### RIVERSIDE DRIVE PROJECT DESIGN QUESTIONS

#### WisDOT Riverside Drive Project

## CSS Costs for the Village of Allouez based on CSS Workshop No.3 exhibits

# Bicycle Accommodations October 8, 2014

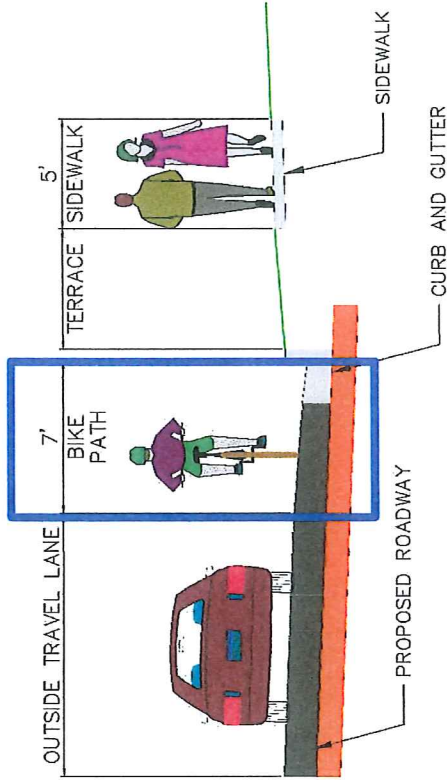
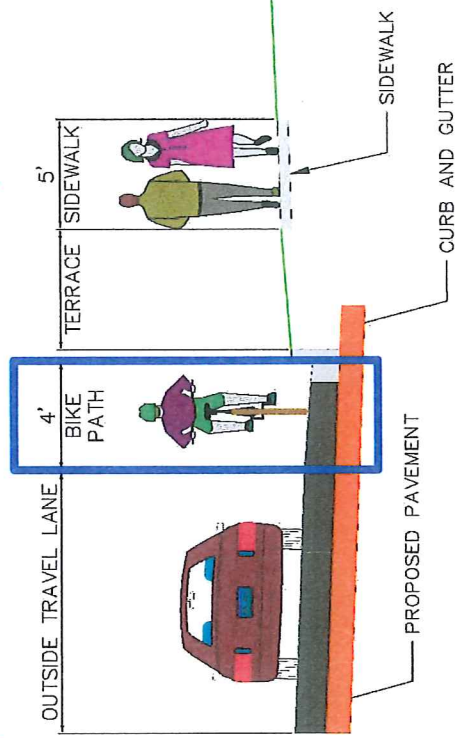
2. Include bike lanes (4 ft wide) in project. The state budget funding may impact this decision. If bike lanes remain in project this helps lower vehicle speeds. If bike lanes deleted roadway will probably stay the same width. *See page 4.*

# Deciduous Trees

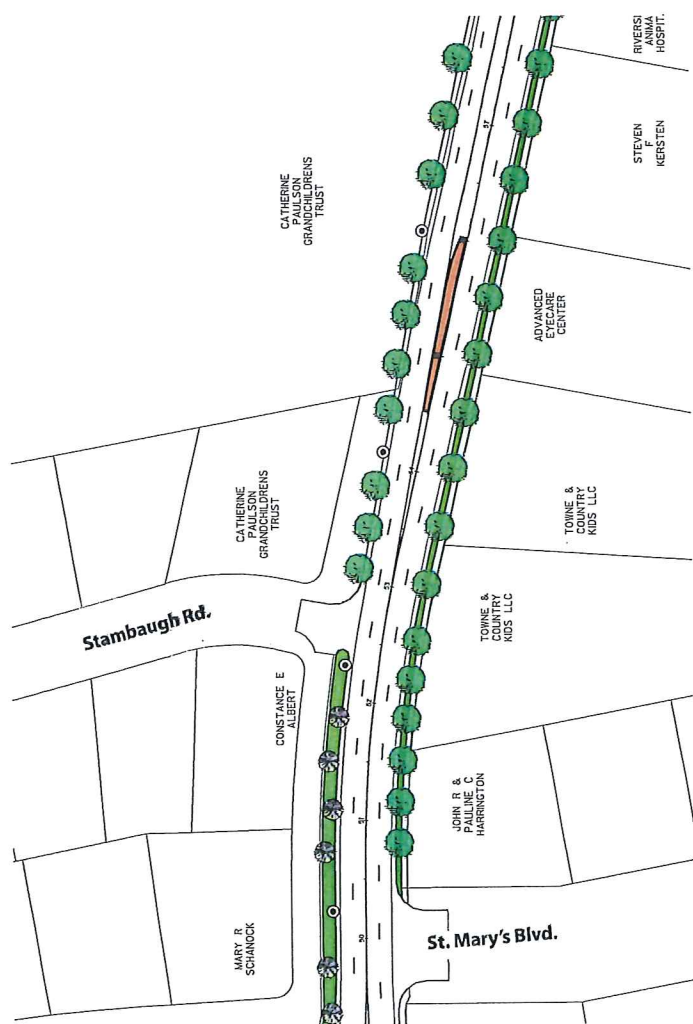
Budget for this cost. Limited trees in medians. See pages 13 & 14.

# Stamped Finish - Medians

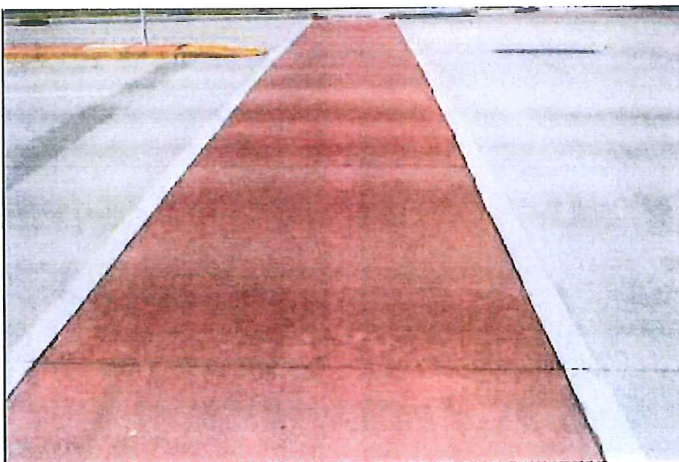
Accent the medians-enhances safety. Optional-requires sealing to reduce salt. See page 9.
